Report: TAB Report
Function: Test, Adjust, & Balance
Date: 03/11/2026
Completed By: National TAB

PROJECT
03-09-26 QT #0484 PEORIA, AZ

Project: 03-09-26 QT #0484 PEORIA, AZ

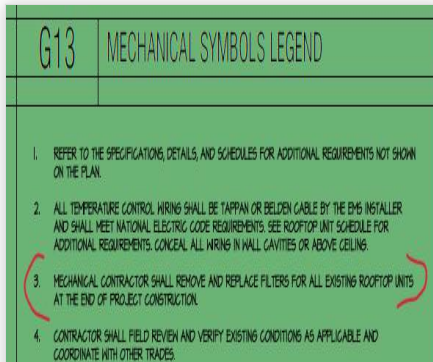
Issue Name : CAN'T TILT EF3 FAN BACK
Description : EF3 was installed incorrectly. Not sure why 2 hinges were installed... but neither of them work. The top, the only one necessary, won't open due to back edge of base hitting the hinges and curb top as shown below. Recommend checking equipment function after installation.
Created By : National TAB **Assigned To :** National TAB - Dan Hertenstein
Status : Open
Priority : Low **Asset Tag :** EF3
Originated Date : 03/11/2026 - Christine Weale - National TAB

Asset: RT-2

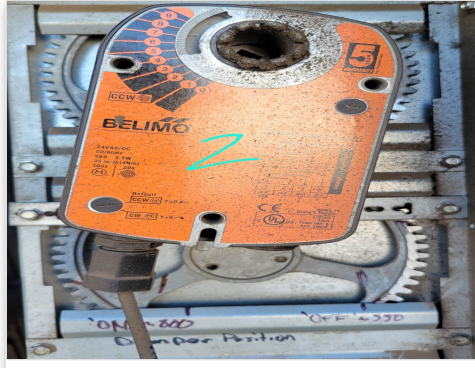
Notes:
RTU2 INCREASED DUE TO LOW BP.

Asset: EF1

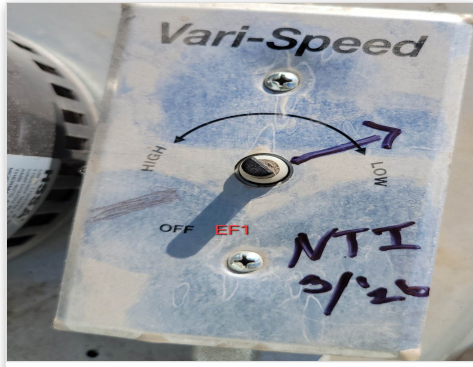
LOW SP DUE TO BROKEN BACKDRAFT DAMPER, SEE 'REMARKS'.

Asset: EF2

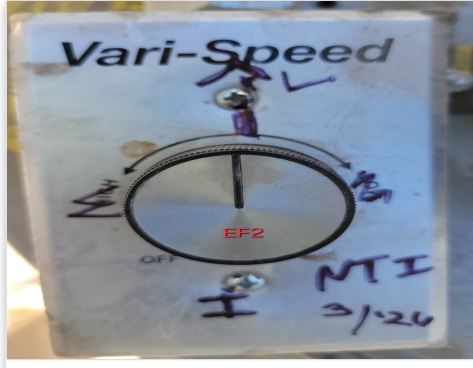
FAN IS BALANCED, FLOW BEFORE AIR DIVERTED FROM MEN'S RR DUCT WAS ~500-545CFM. DUCT ISSUE - SEE 'REMARKS'.
